**Questions for CanWhite Virtual Open House for the Vivian Sand Extraction Project  
and Hydrogeological Report  
by D.M. LeNeveu B.Sc. (hons. physics) M.Sc. (biophysics) B.Ed.  
Aug. 20, 2021**

**Figure 1.** Limestone thickness in the carbonate aquifer of the CWS BRU extraction area.

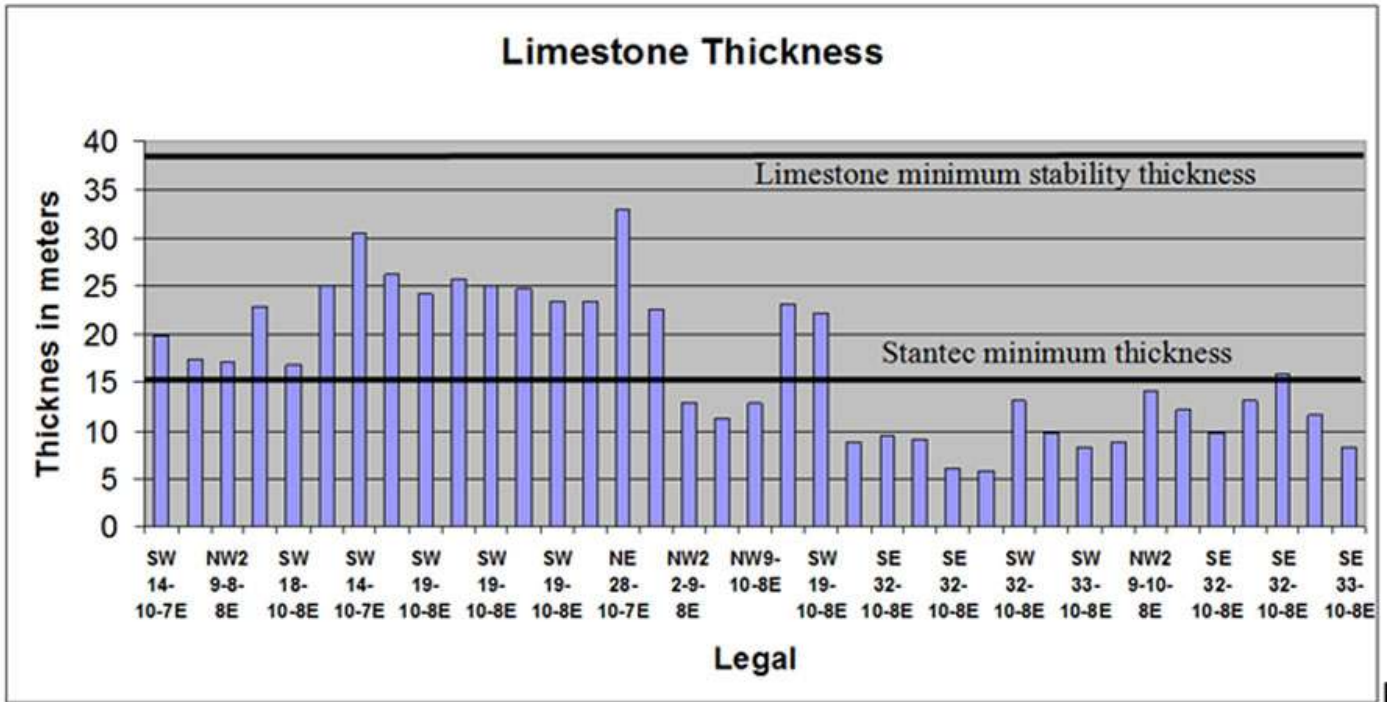
A peer reviewed paper by Waltham and P. Fookes specifies that minimum stability thickness for limestone above a cavity must be 70% of the cavity opening dimension excluding overburden cover.<sup>1</sup> For the CWS standard design opening for a seven well extraction cluster the limestone thickness must be at least 37.8 m. The limestone of the carbonate aquifer in the Bru extraction area has a thick overburden cover of glacial till whose unsupported weight will increase the minimum stability thickness for the limestone.

Figure 1 shows the limestone thickness of the carbonate aquifer in the Bru extraction area and the Stantec and Waltham and Fookes thickness limits. The data was taken from CWS well records supplied by Manitoba Groundwater and from the CWS borehole records in the hydrogeological report. The well records demonstrate that over the entire Bru extraction area all limestone thicknesses are less than the minimum criteria stated by Waltham and Fookes for stability. All limestone thicknesses in the eastern Bru area where extraction activities will begin are less than the Stantec limit of 15 meters. The limestone thickness in general increases westward.<sup>13</sup>

**Question:**

**Will CWS move their operations westward into the ALY area where the limestone is thicker and the sandstone aquifer is saline to avoid subsidence?**

**Figure 2.** Cover collapse sinkholes from USGS.<sup>3</sup>

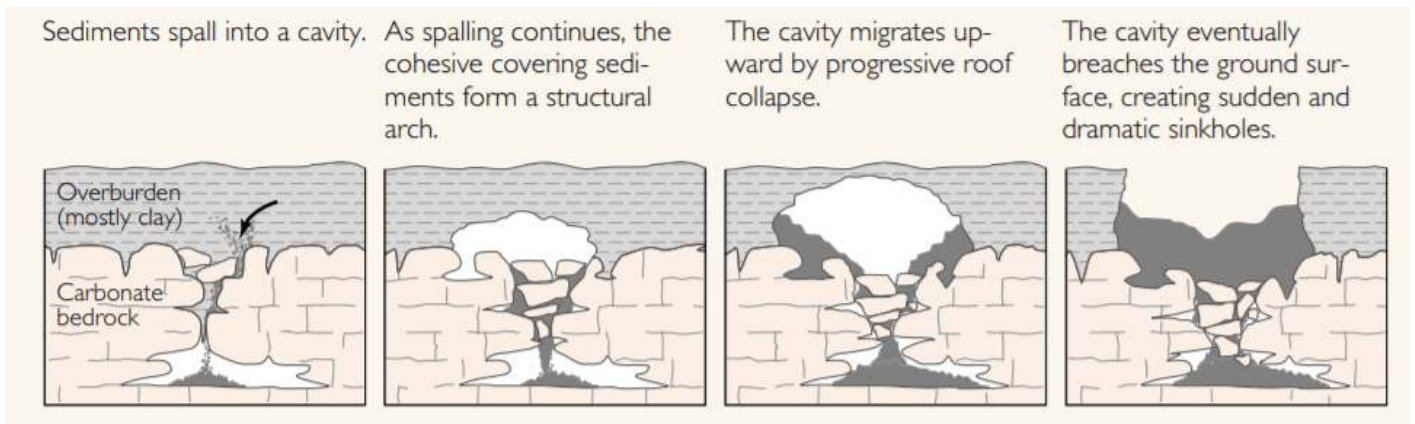
The glacial till overburden will gradually migrate into the cavity through the compromised limestone layer causing a cover collapse condition. In cover collapse subsidence the cavity created in the till overburden by gradual migration through the limestone layer will suddenly collapse at some undetermined time in the future leaving a large sinkhole as illustrated in Figures 2 and 3. All of the well clusters created by CWS operations are susceptible to cover collapse. A moonscape of water filled sinkholes will be eventually created. Water contaminated iron bacteria, fecal coliform from septic fields and animal feces, other microbes, and chemicals from surface runoff will have direct access to the carbonate aquifer and the sandstone through the compromised shale aquitard. This subsidence scenario is untenable.

**Figure 3.** Sinkhole development from CWS sand extraction<sup>2</sup>

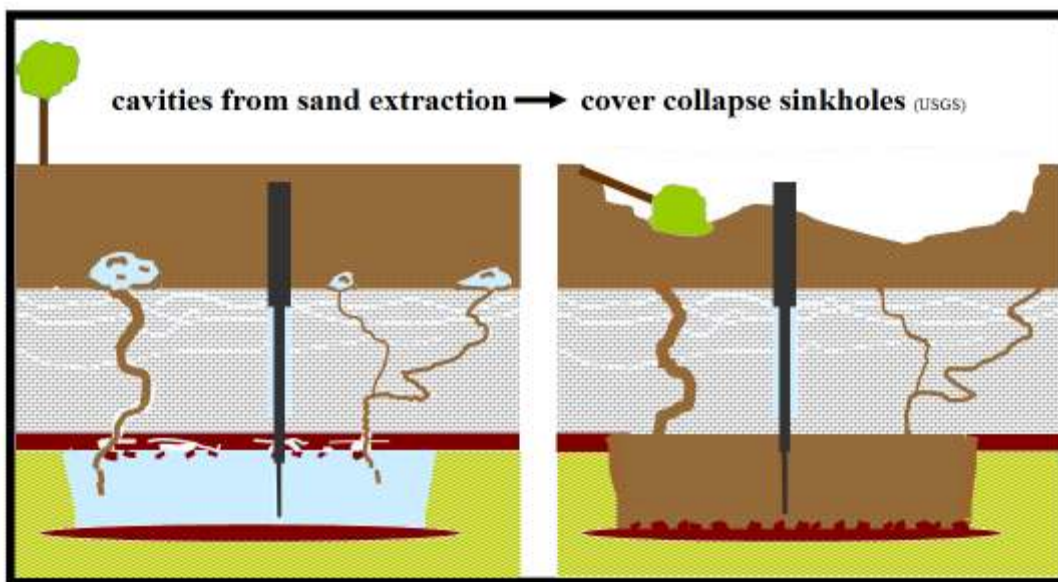
A report released by What the Frack Manitoba in February 2021, peer reviewed by A. Ingraffea of Cornell University a world renowned expert on geo-mechanics, determines the shale aquitard will be unstable and slake into the cavity from the sand extraction.<sup>2</sup>

**Figure 4.** CWS 24 year project area overlaid on the map of the extent of the Carman sands (green speckled area) south of Vivian MB.

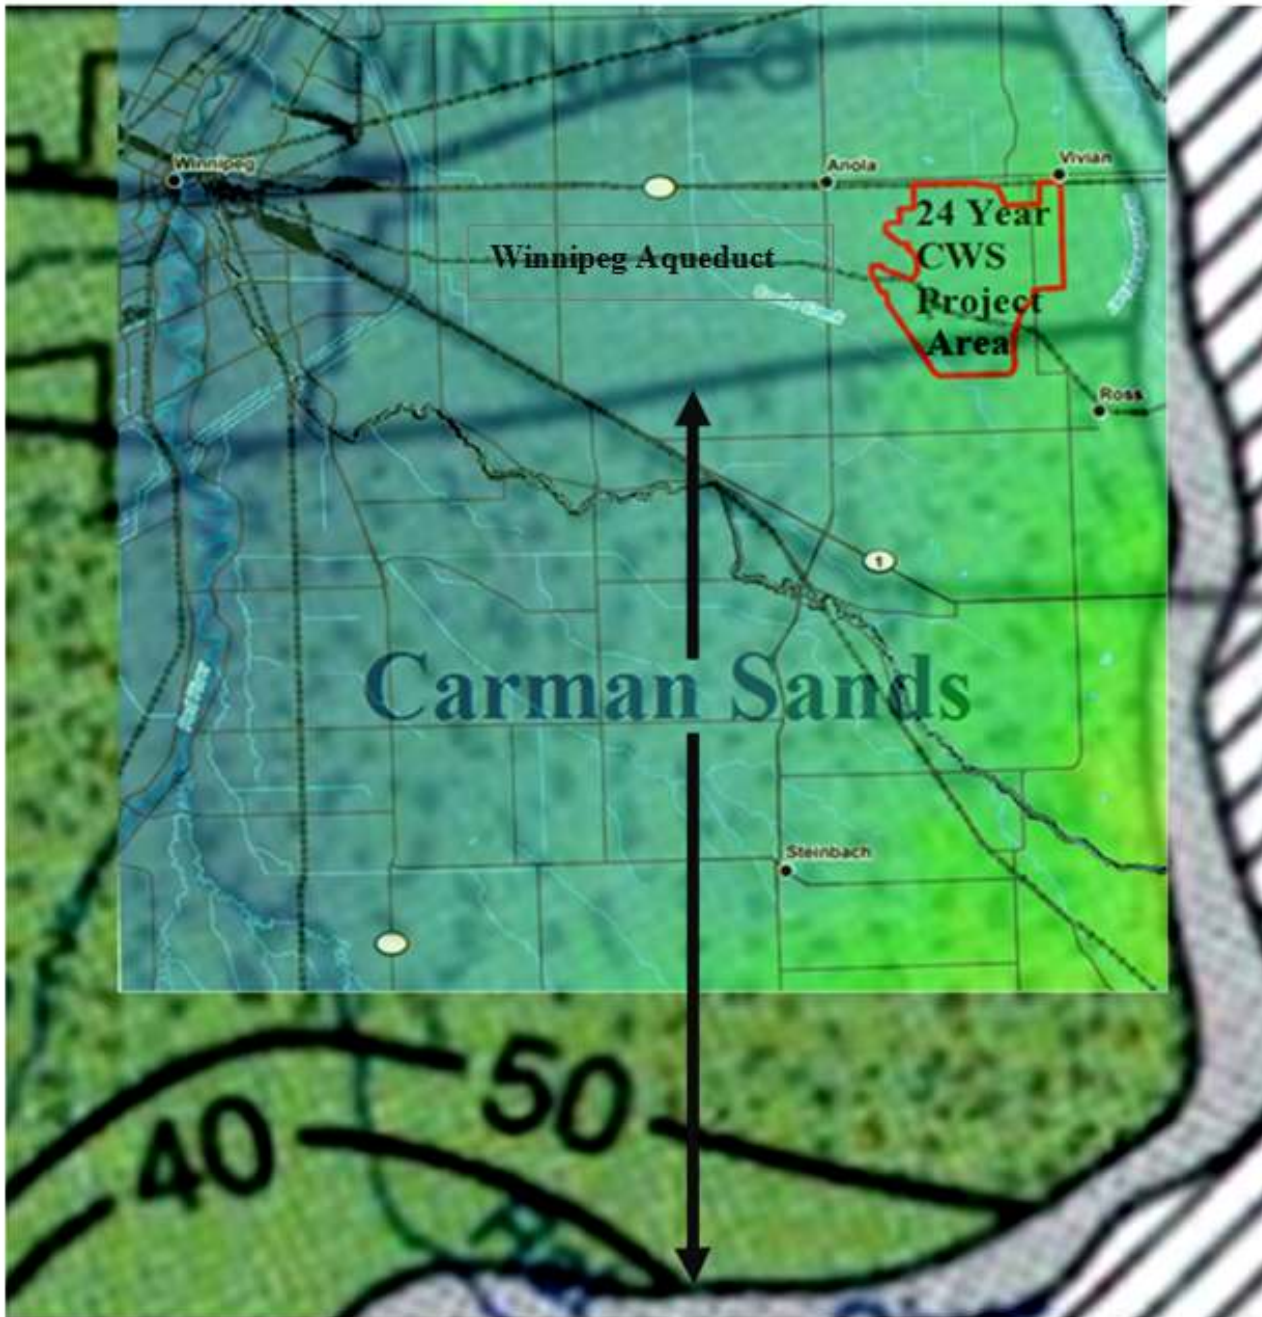
The above quote states the Carman Sands are below the Sandilands area. Figure 4 shows the Carman Sands as determined from the Manitoba Energy and Mines Bedrock Geology Compilation Map Series <sup>13</sup> overlaid on the CWS 24 year Project area. Figure 4 clearly shows only very southern portion of the project area is within the Carman sands.

Thus even the lower portion of the Carman Sands in the southern portion of the claim area is interbedded with shale that is likely rich in pyrite.

**Does CWS acknowledge the northern part of the BRU project area is wholly within the Black Island member part of the Winnipeg formation known to contain pyritic shale, marcasite coating the sand, pyritic concretions such as oolite layers and not within the Carman sands area?<sup>10,12,14,15</sup> Does CWS acknowledge that the Black Island member from which sand will be extracted in the northern portion of the Bru area contains pyrite that will be exposed to re-injected aerated water that will form acid and mobilize heavy metals and selenium thereby contaminating the aquifer?**

As illustrated in figure 4 the Winnipeg aqueduct traverses the entire 24 year CWS project area. The slurry lines will eventually have to cross the aqueduct likely multiple times. The aqueduct is known to have cracks
